Report No. EGG-EA-5338

Adequacy of Station Electric Distribution System Voltages, Crystal River Unit 3,
Docket No. 50-302, TAC No. 12743

ADEQUACY OF STATION ELECTRIC DISTRIBUTION SYSTEM VOLTAGES

CRYSTAL RIVER UNIT 3

CRYSTAL RIVER
UNIT 3
ONE LINE DIAGRAM
FIGURE 1

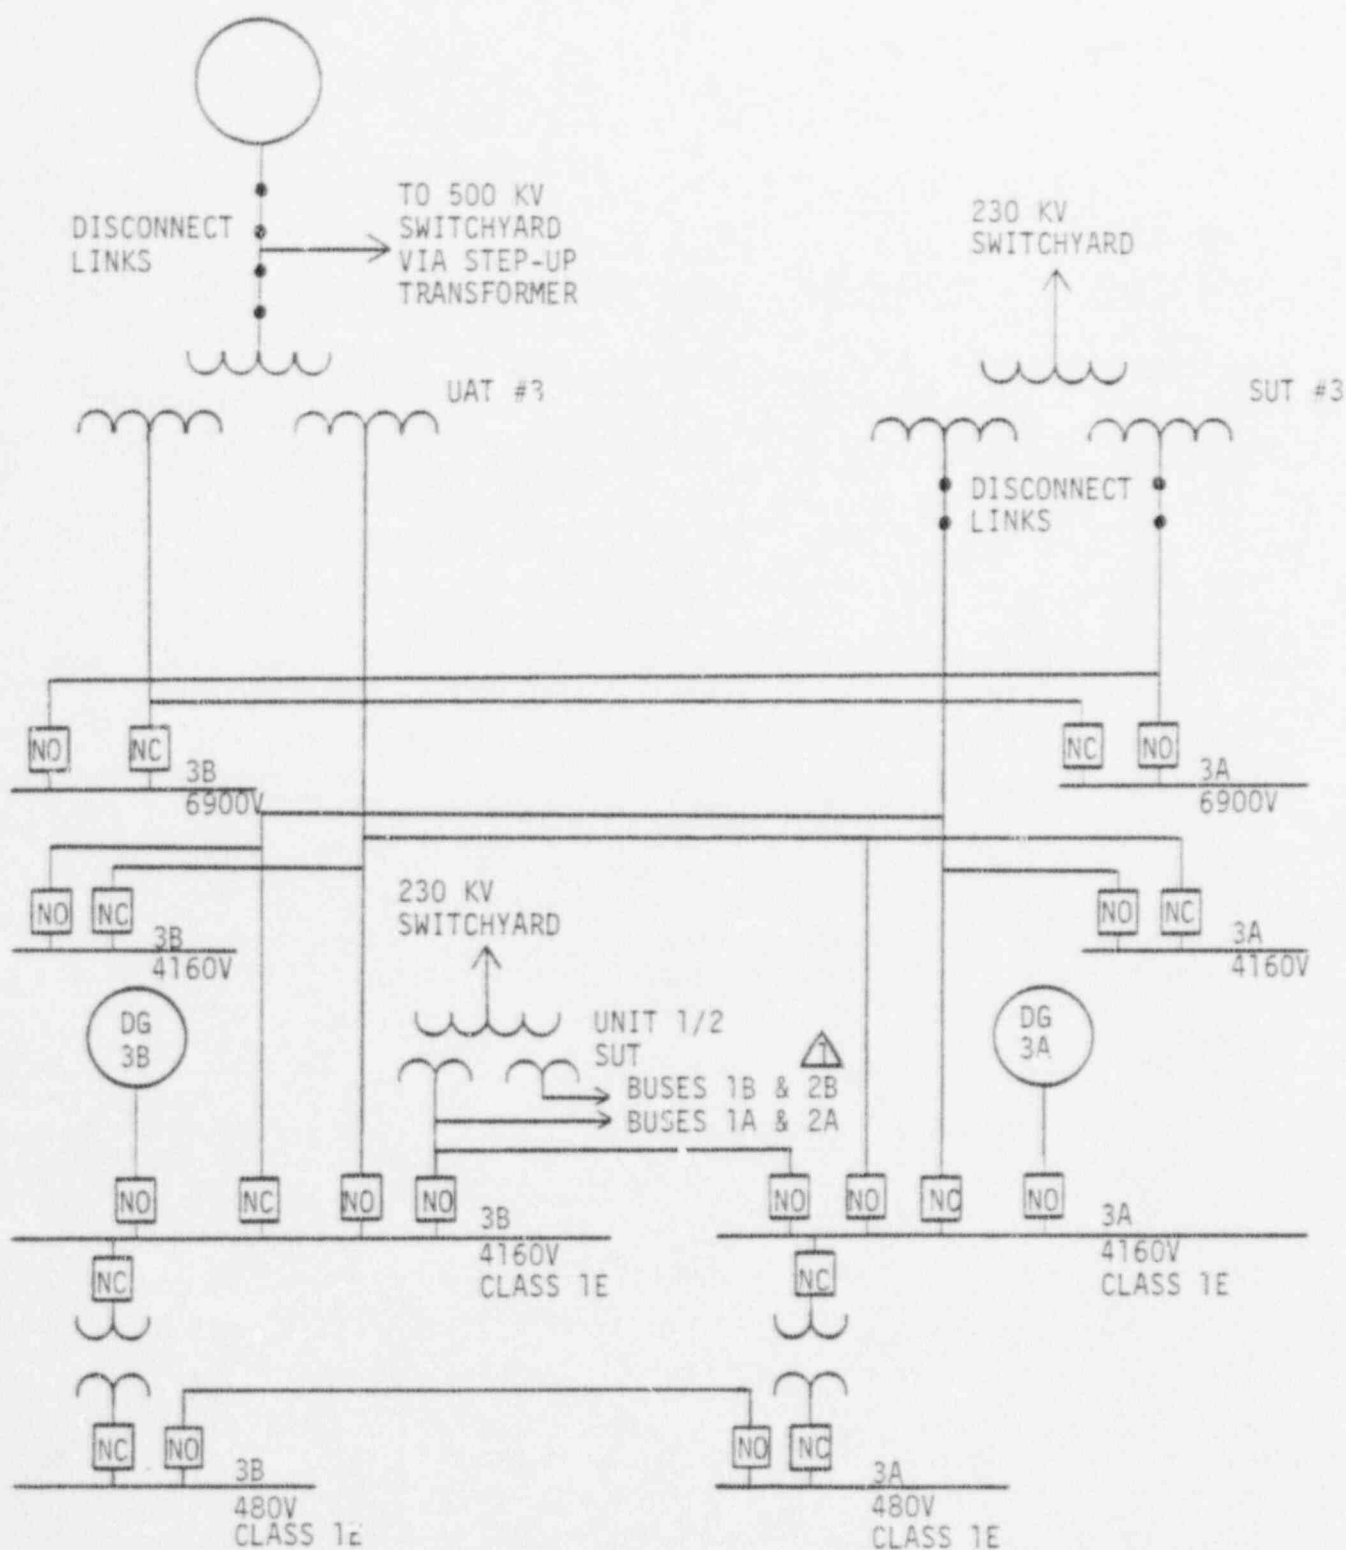
Figure 1 is a simplified sketch of the Crystal River Unit 3 (CR3) one-line diagram taken from Amendment 42 FSAR Figures 8-8 and 8-9. Units 1 and 2 are not nuclear units.
